# **AMENDMENTS TO THE DRAWINGS**

## **REMARKS**

Fig.2

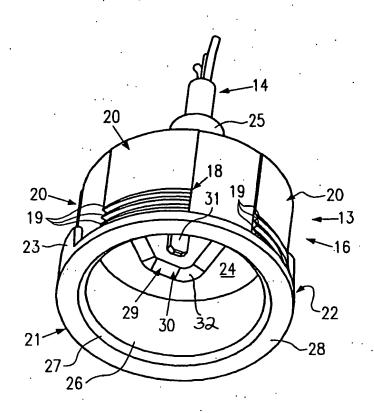
Replace FIGS. 2, 6, and 8 with the replacement sheets including amended FIGS. 2, 6, and 8 attached to this communication. FIG. 2 has been amended to add numeral 32. FIG. 6 has been amended to change one of the numeral 66's to a 68. FIG. 8 has been amended to change one of the numeral 92's to a 91. Annotated sheets indicating the changes in red ink are also enclosed. No new matter has been added.

The Examiner objected to the drawings because they do not include several reference signs. Applicants have amended Figs. 2, 6, and 8 to add in the noted missing reference signs.
